ADDENDUM: **TWO**

DATE: 10 March 2021

PROJECT TITLE: **LeConte College Maintenance Renovation (RE-BID)**
SC Project No.: H27-6126-LC
University of South Carolina

This addendum is issued to clarify and revise the Bidding Documents which have been previously issued.

FOURTH FLOOR HVAC PIPING PLAN
SCALE: 1/8" = 1'-0"

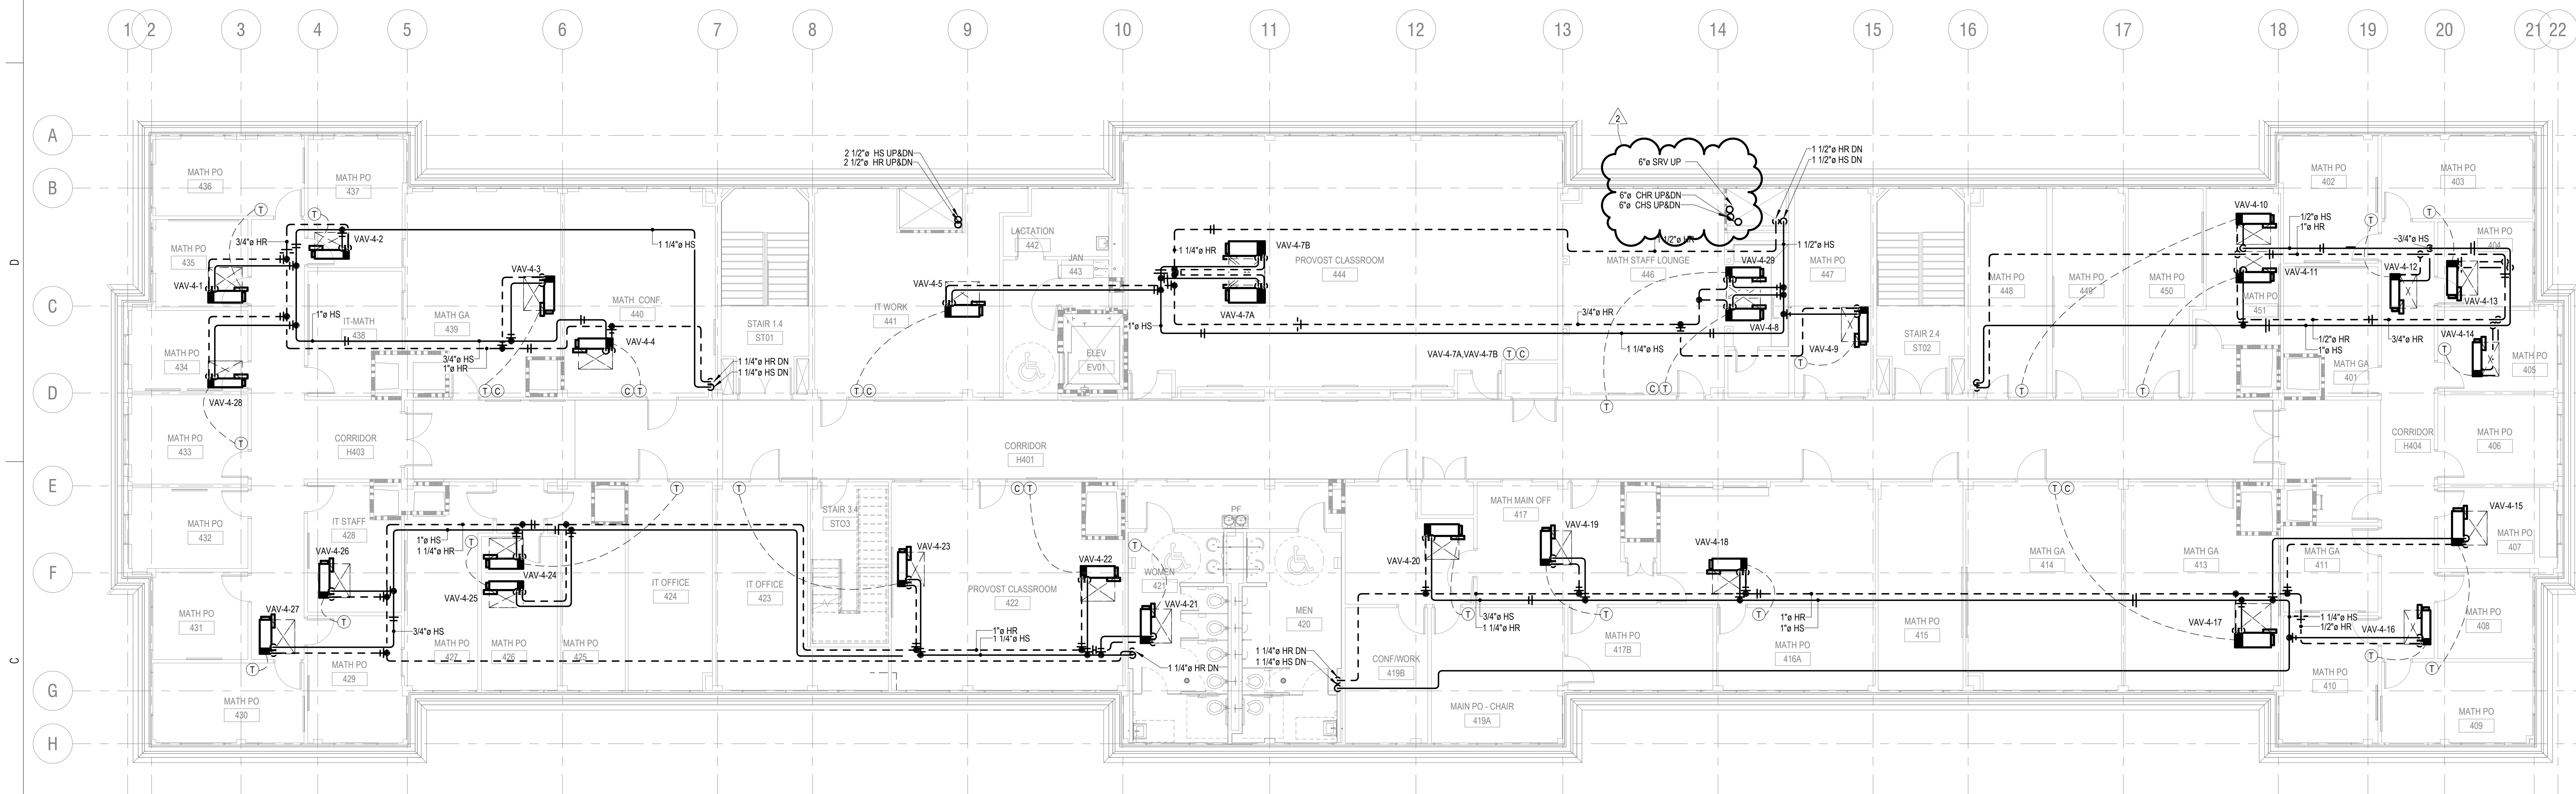
| 5. | <u>Drawing M-204:</u> Pipe sizes updated to match new chilled water flow rates. |

1 ATTIC HVAC PIPING PLAN
SCALE: 1/8" = 1'-0"

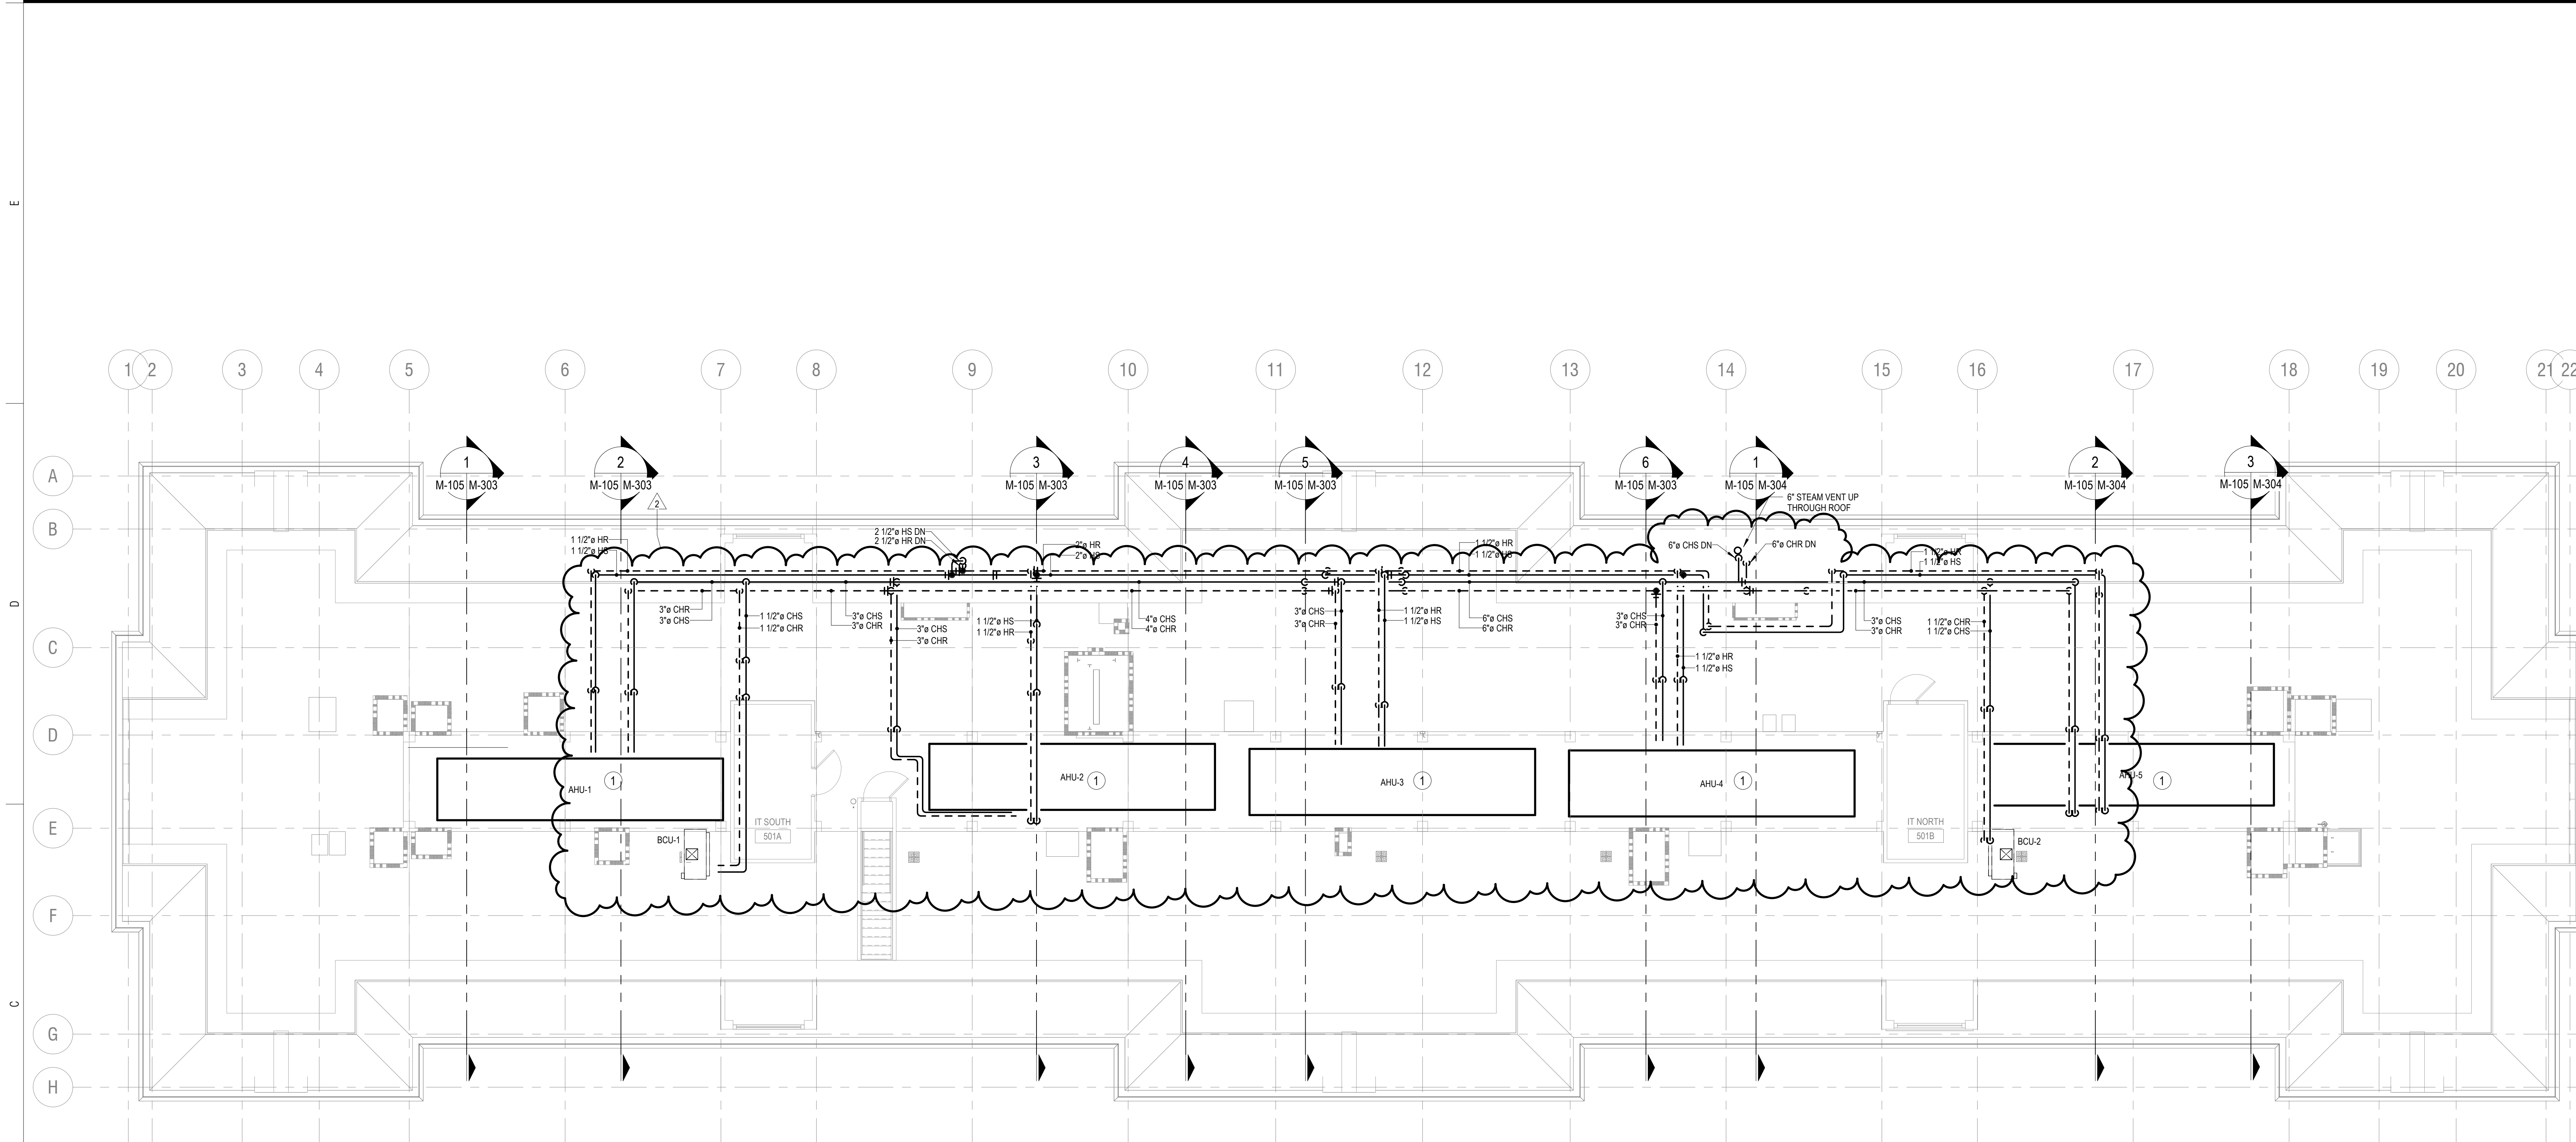
| 6. | <u>Drawing M-205:</u> Pipe sizes updated to match new chilled water flow rates. |

1 FIRST FLOOR FLOOR LIGHTING PLAN
SCALE: 1/8" = 1'-0"

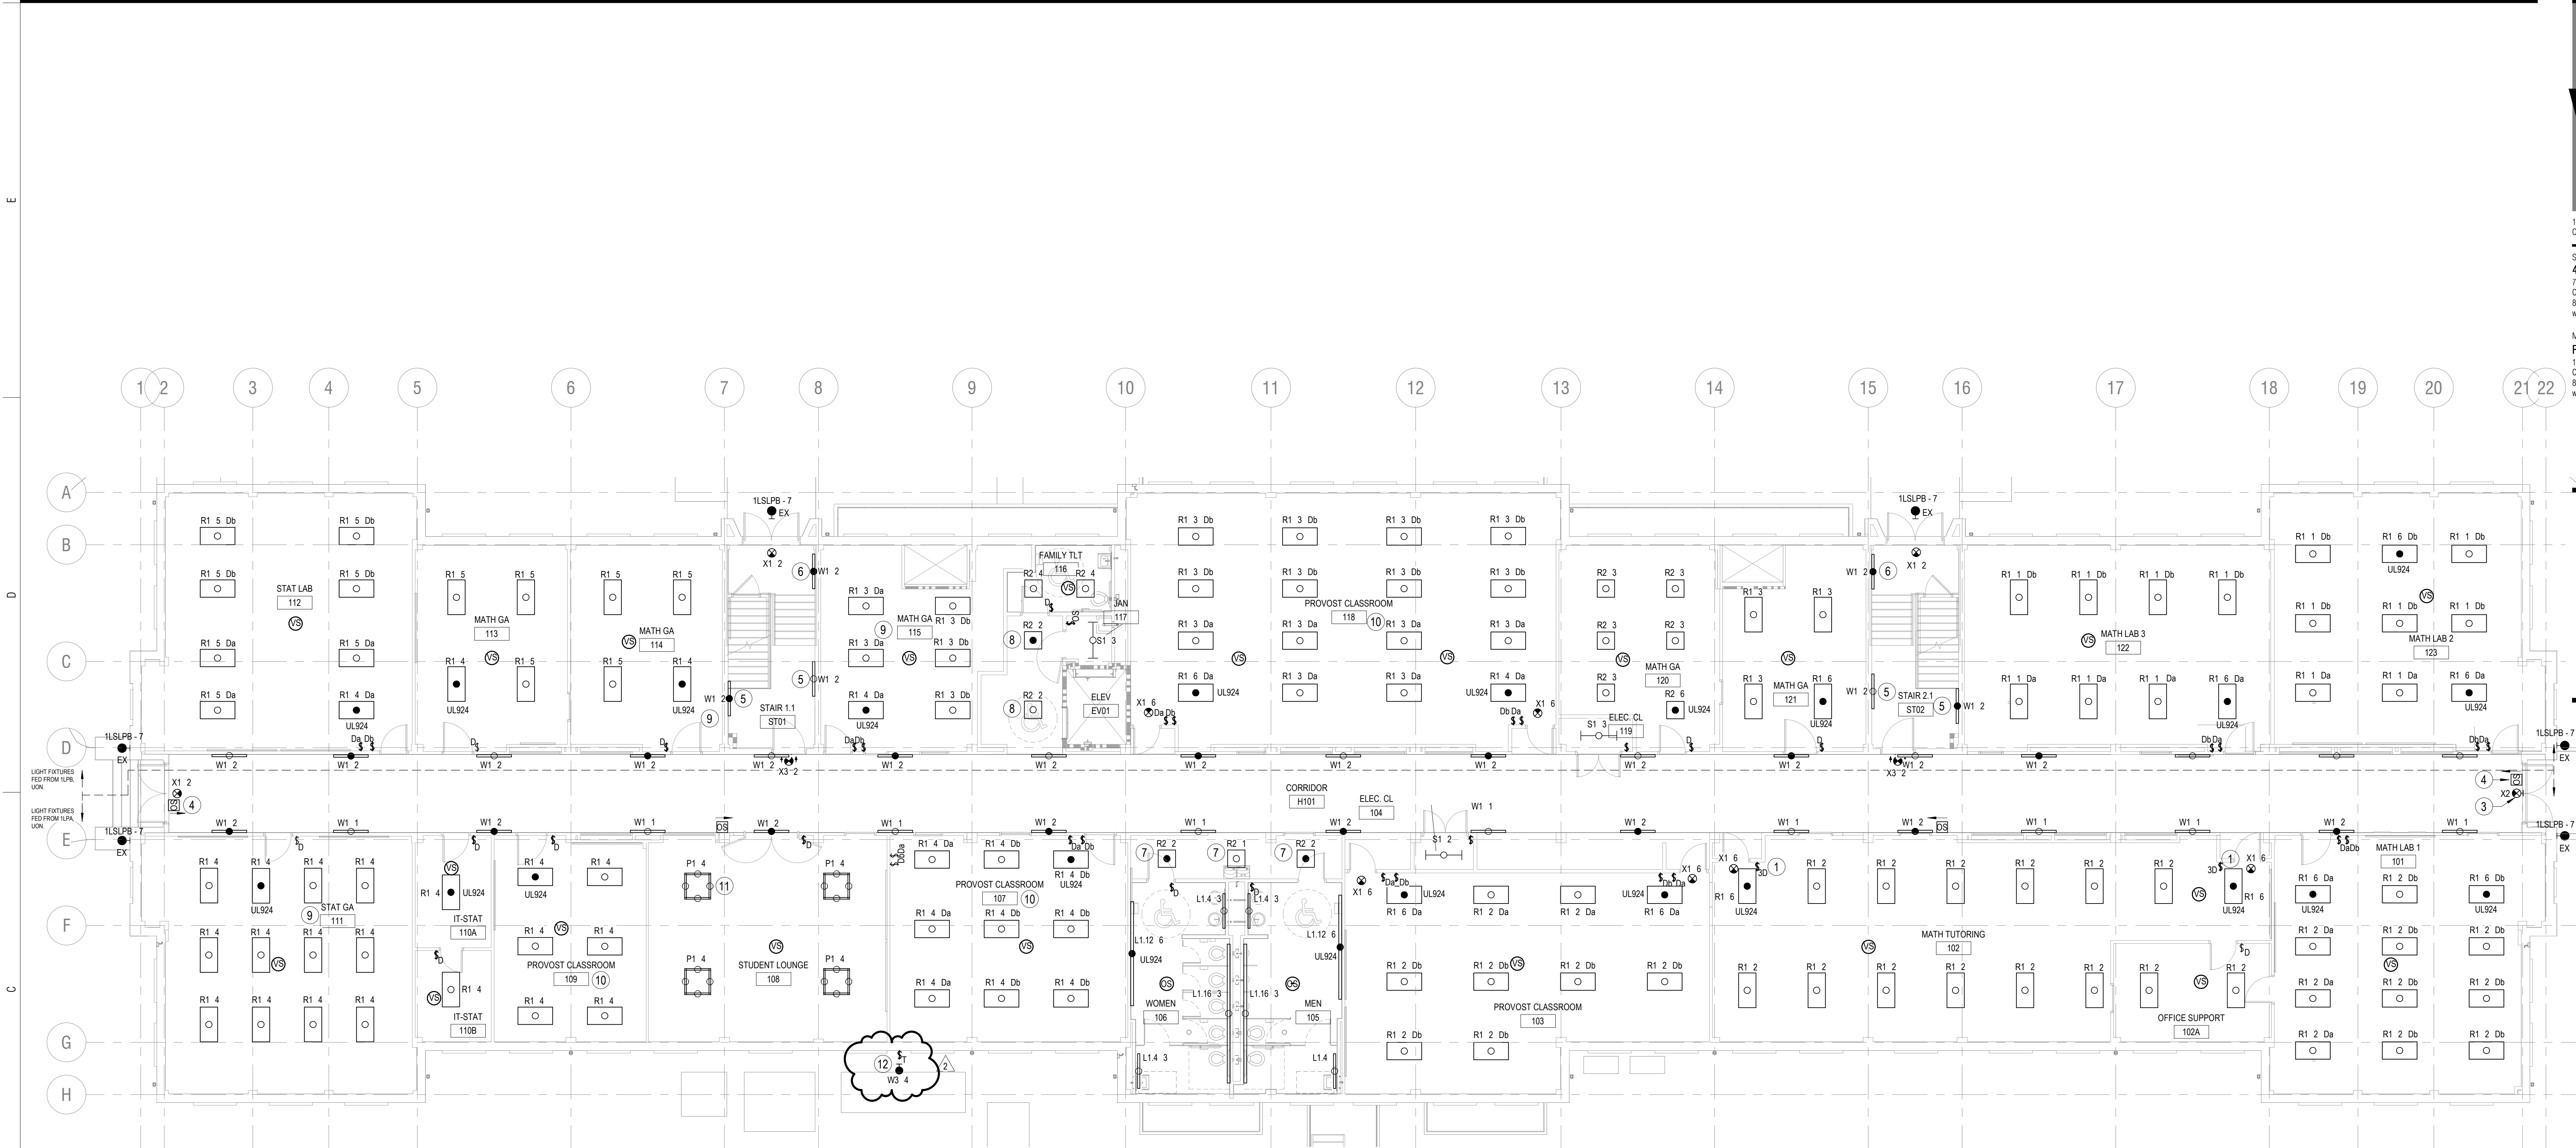
| 13. | <u>Drawing E-201:</u> Location of exterior W3 fixture is updated. Provide exterior timer switch for W3 fixture. All devices, conduit and fixture colors shall be coordinated with architect. |
